ADDENDUM NO. 02

DATE: March 17, 2023

CONTRACT NO.: ES-0043-C02

PROJECT: Orange - Cleveland Street Elementary School – Addition and Renovation

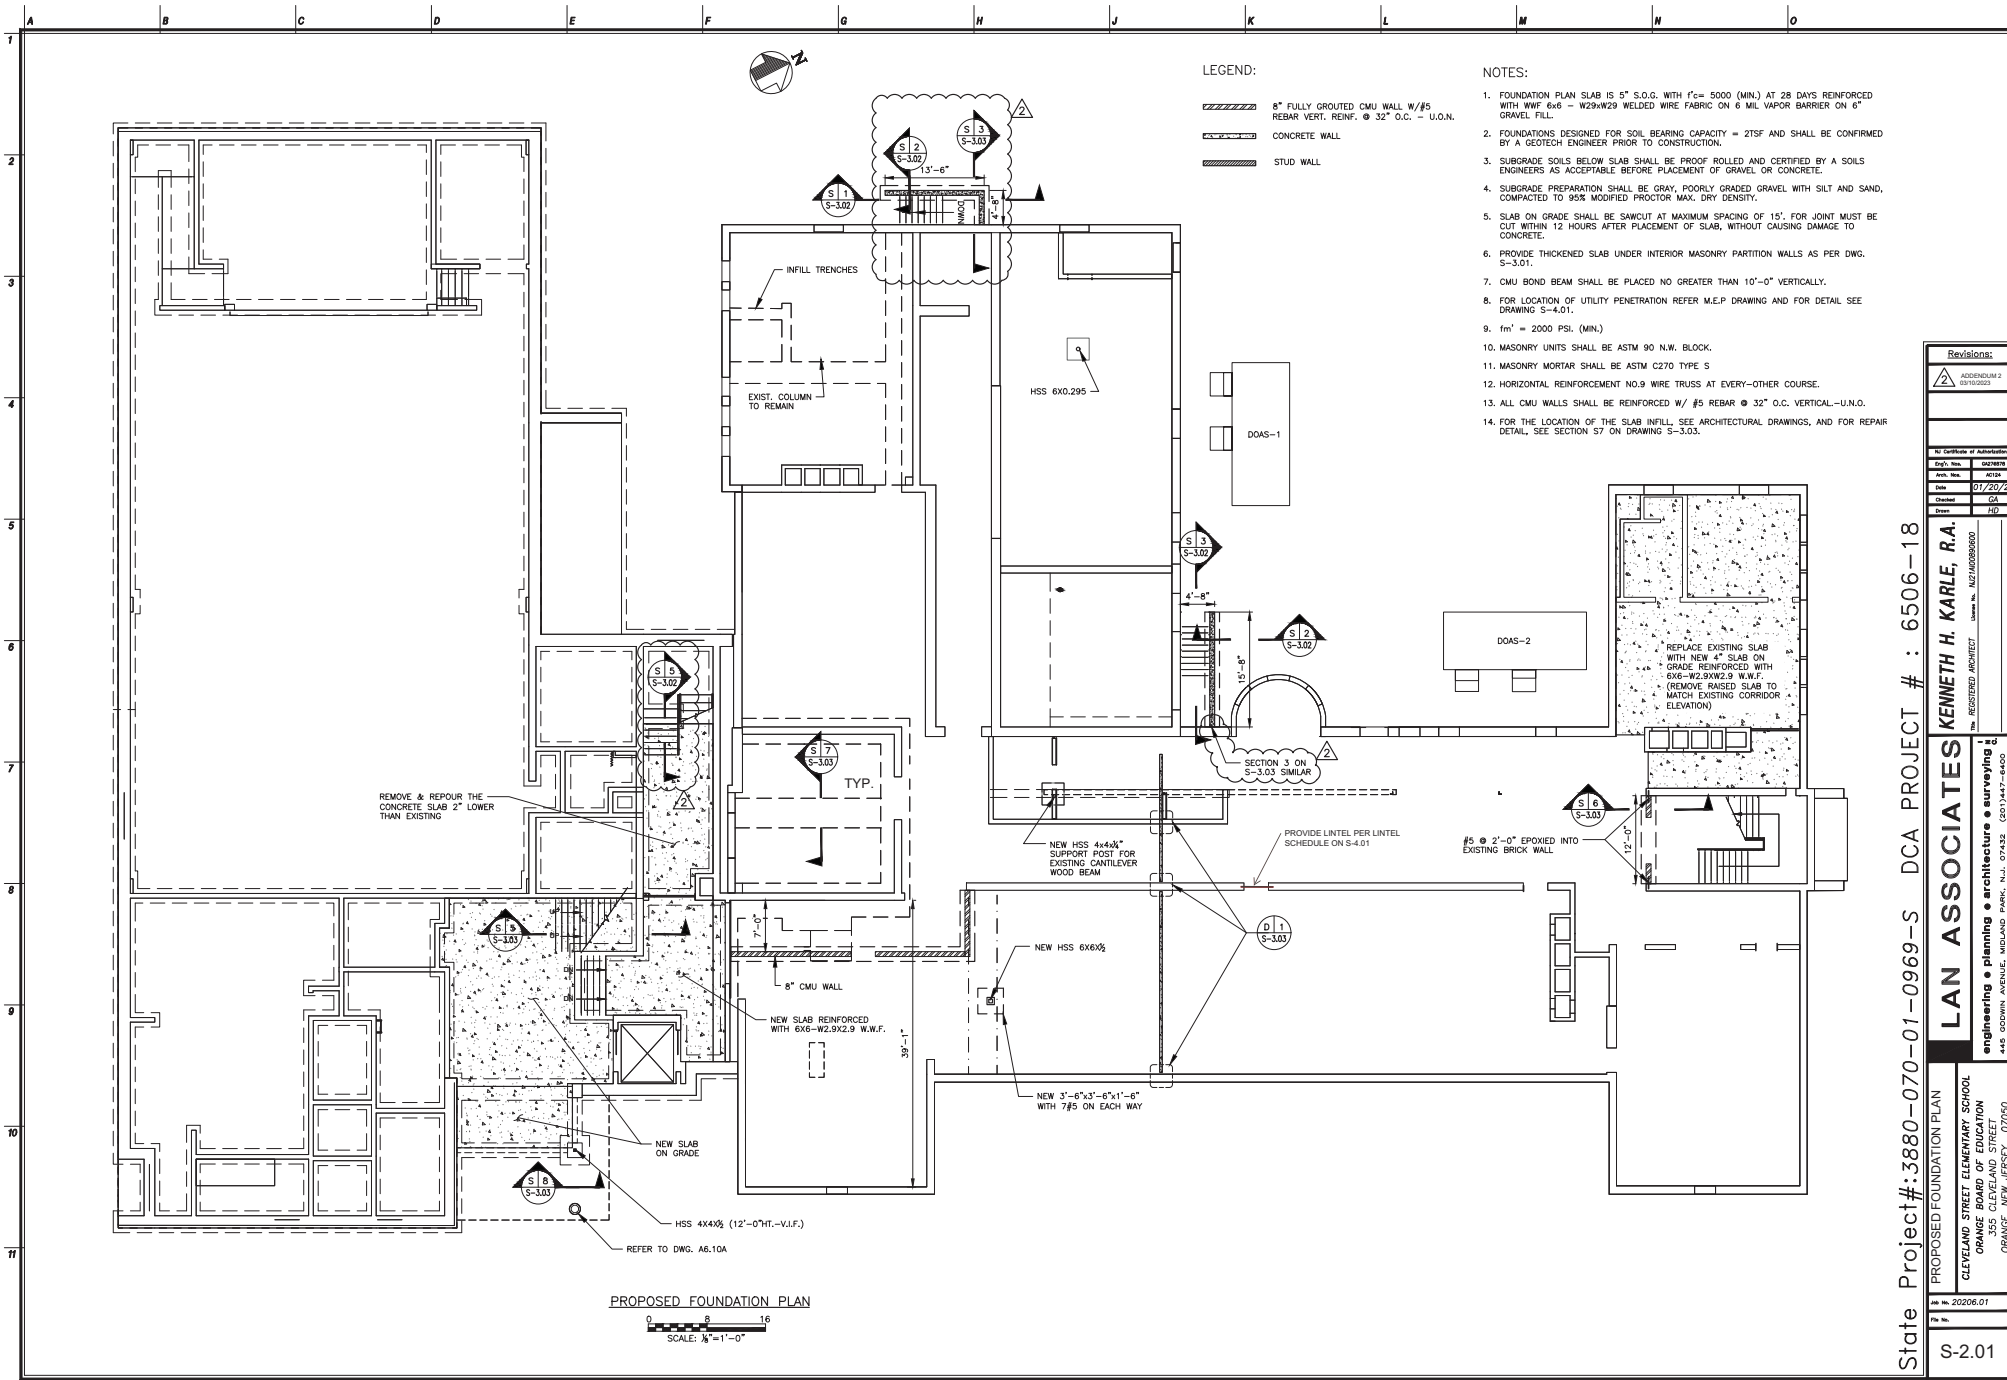
Bidder Question #03: Drawing S-2.01 referring to det. S2/S-3.02. Det. S2 is missing. Please provide.

Response: See revised Structural Drawings S-2.01 and S-3.02 issued herewith as Attachments 2.03 and 2.04.

S-3.03

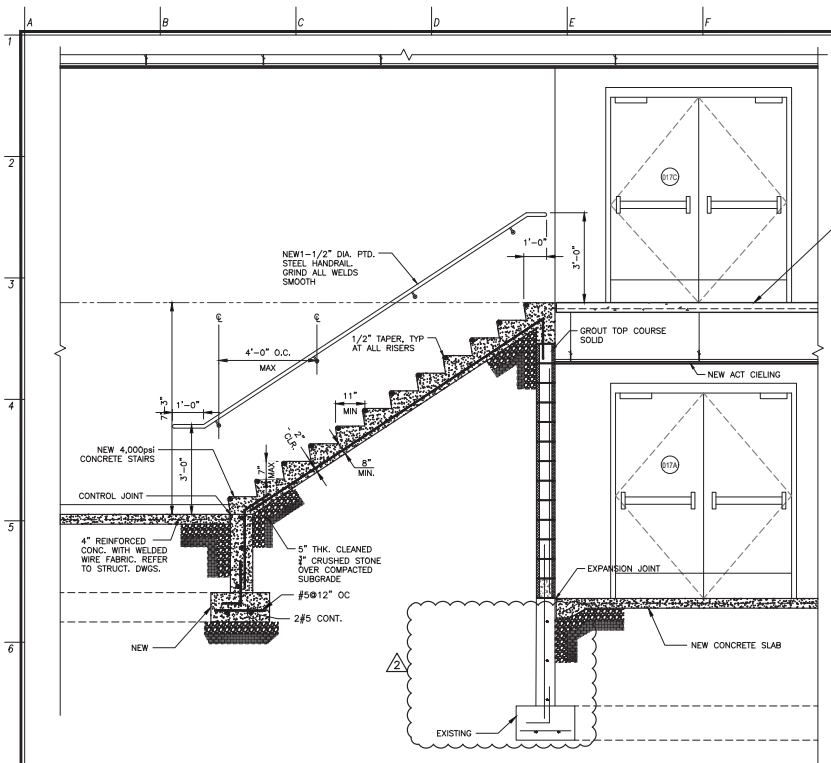
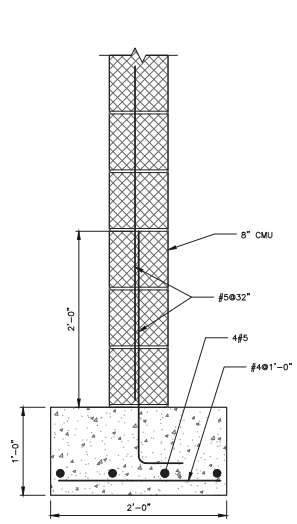
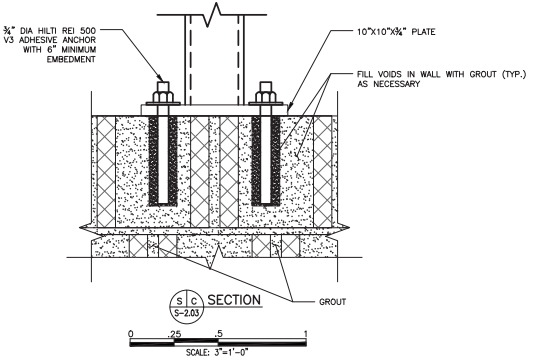
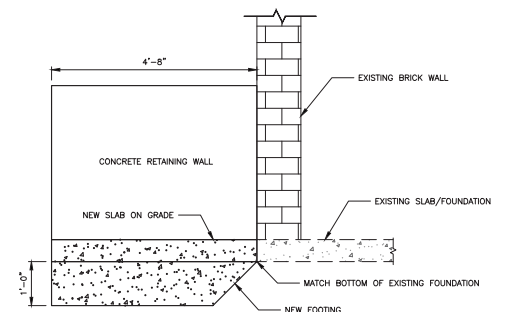
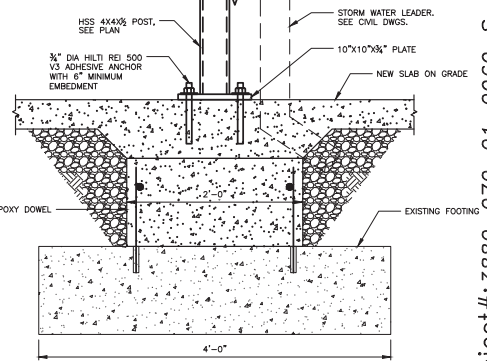
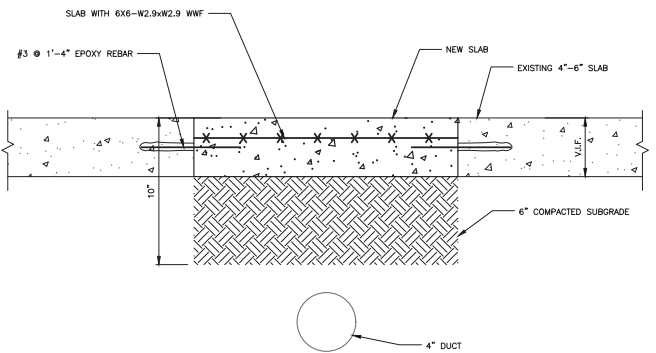
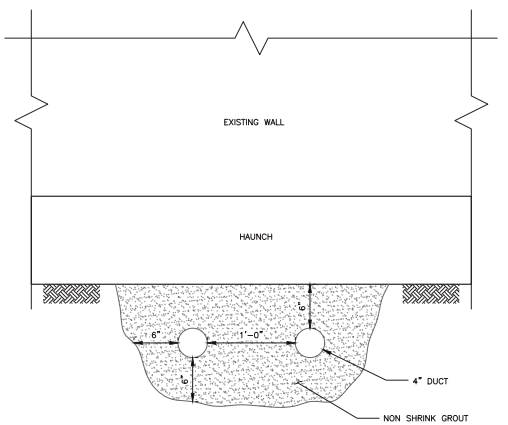
- Bidder Question #04:** Det. 2 & 3/A7.10 showing existing lobby stair footing & foundation to remain, det. S5/S-3.03 showing new footing & foundation for lobby stair. Please clarify.

- Response:** See revised Structural Drawing S-3.03 and revised Architectural Drawing A7.10 issued herewith as Attachments 2.05 and 2.07
- Bidder Question #05:** Drawing A9.06 is not showing Basis of Design of classrooms & office millwork. Should BOD be “Hamilton Sorter” or “Dwyer Prodct”? Please clarify.
